**RE: Cambridge Re-signalling, Relock and Recontrol (C3R) Meldreth Road Crossing**

**Ref: Cambridge Resignalling, Relock and Recontrol (C3R) programme – Network Rail's response to objections received against proposed upgrade of Meldreth Road level crossing**

**Meldreth Road Level crossing Enquiry Supplemental commentary on NR response and further information**

Figure 2 Track arrangement comparison.

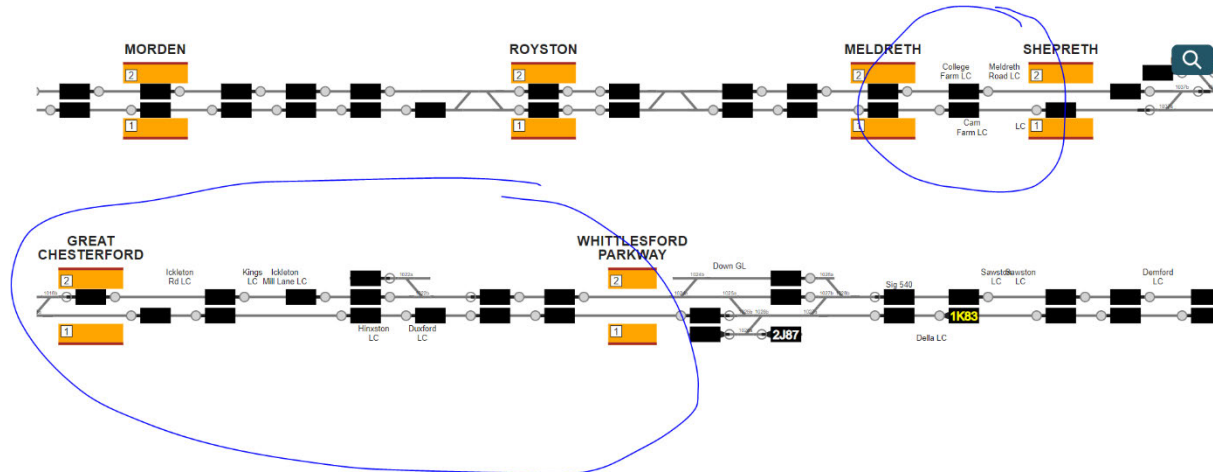
Consequence – to effectively establish the impact to the LC, accurate modelling of what will happen is required. As noted in the introduction the situation at Shepreth Station the locals have encountered has not been satisfactory and there is something funny with the arrangement nearby that is the cause of this. You can see below the track layout for the Hinxton Crossing (middle bottom) compared to Meldreth (top right).

As you see the Hinxton Crossing is well between two stations at a distance of 2km and 3.3km. Whilst the Meldreth station is 0.5km and 2.5km from the adjacent stations. Why this matters is that the 4 barrier LC down time does not discriminate between fast and slow (stopper) services. The increased down time at Shepreth is compounded by the fact that a number of trains are breaking to stop at the station. This means added down time for those trains. As the LC at Meldreth road is closer to stations it is therefore impacted more by this.

It is also noted that the Hinxton Station is also on a different line and it isn't clear if the balance of slow, fast and goods services is the same.

Therefore the use of the Hinxton data is not believed to be correct or yielding accurate results. It should be simple maths "a train is travelling at X speed and decelerates constantly etc etc" to establish the true figures.

*Figure 3 the “Vissim” model peak time in seconds across the bottom.*

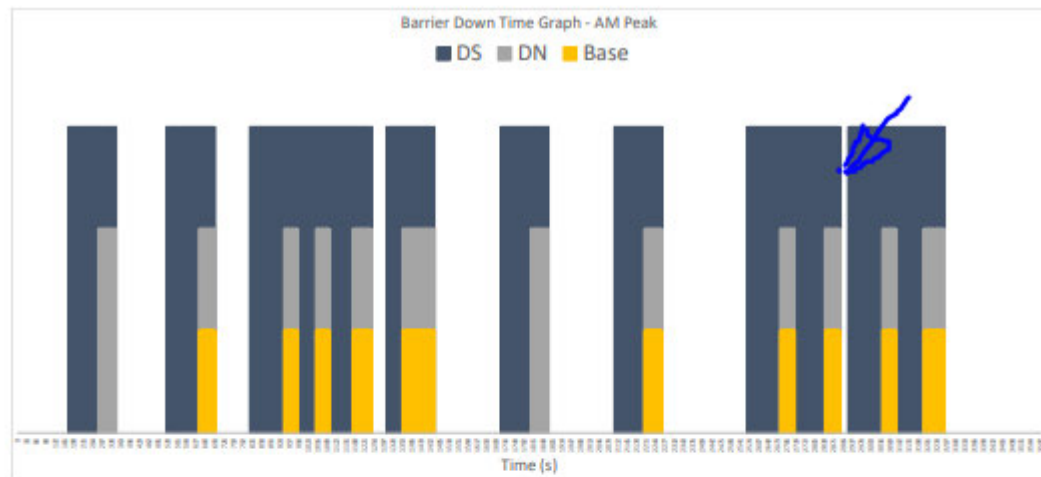
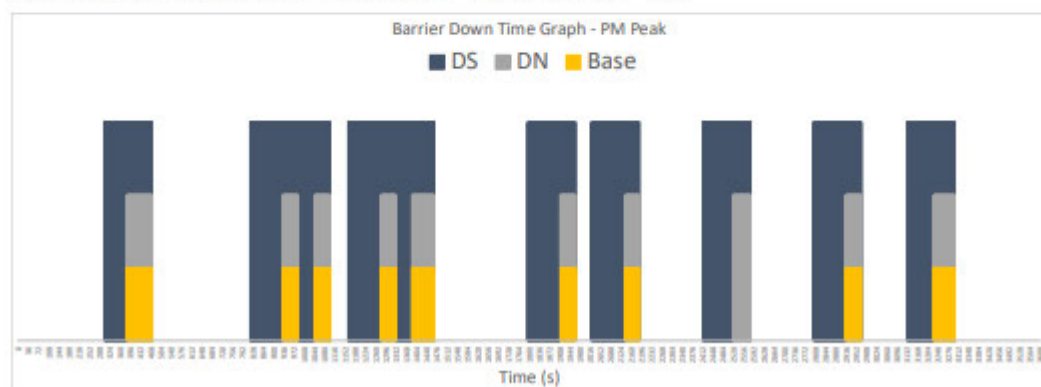
- The modelling for the downtime demonstrates significant increase in downtime but this is not reflected in the conclusion which cites “no significant impact on the network” and “modest increases in journey time”.

Consequence: again failure to report results from the modelling does not allow for suitable critique of the proposal. The above figure shows that the downtime is not only increased but overlaps a number of trains. (Current barriers are down for the yellow/grey blocks circa 90 seconds, the proposal is for the blue blocks which range 3-6 minutes). The gap on the top right arrow is 30 seconds between two 6 minutes blocks and could easily result in a 12 minute down time especially as the modelling data is based on inaccurate information and trains aren’t always on time. The record at Shepreth station is circa 17 minutes.

The total barrier down time at peak time is approximately 60% of the whole peak hour, this is an increase from 26% as the current base. That is a doubling of down time at peak and is significant and not addressed.

Figure 4 standard route top of Meldreth to Shepreth 3 minutes

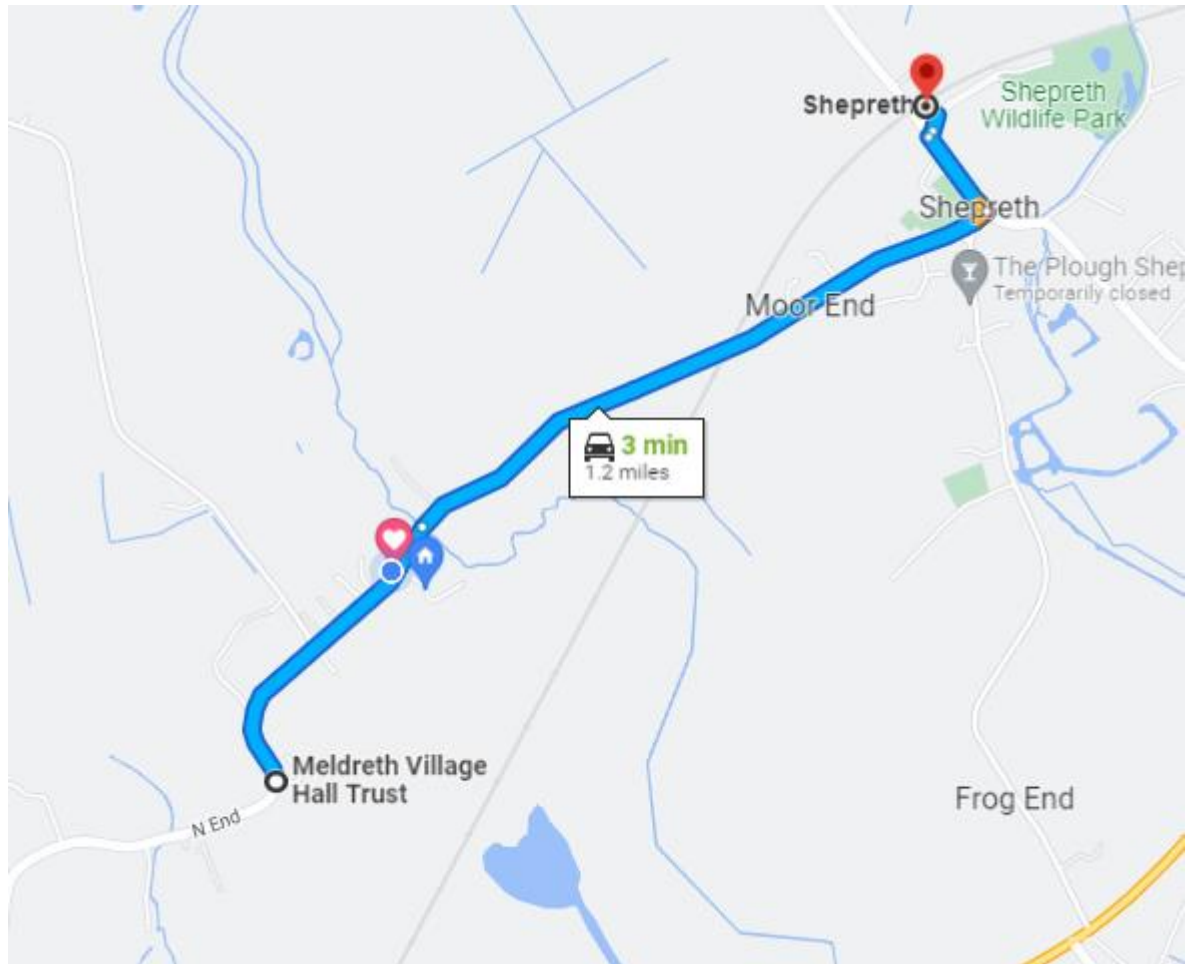
Consequence – Human behaviour isn't based on averages. We make judgements on worse case scenarios rather than the balance of probability. For example Recency bias. People will change behaviours because they get caught by the train for a long time. This will have an impact on the network as those vehicles will increasingly go other ways. This is not considered and the alternative routes are not short, the impact on emergency services could be critical to a patient.

Figure 6 alternative route north 10 minutes

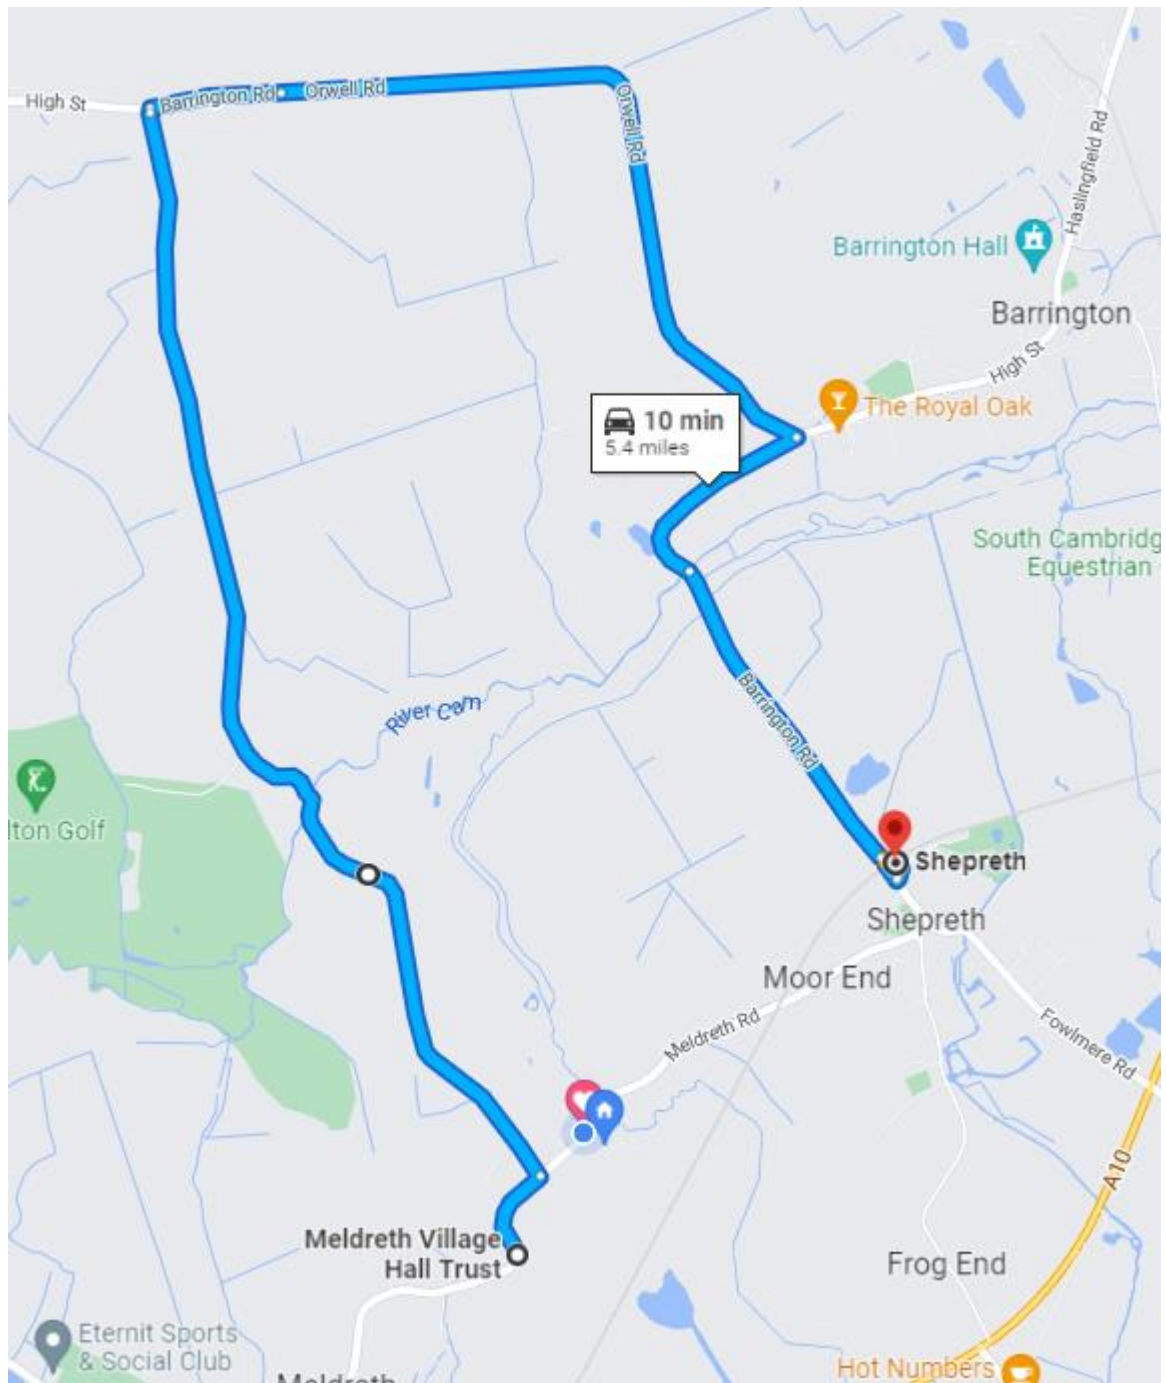
5. The added time creates a significant journey issue for those who travel across both crossings to catch a northbound train. The combination of both Shepreth station LC and Meldreth LC down time is prohibitive to those rail users.
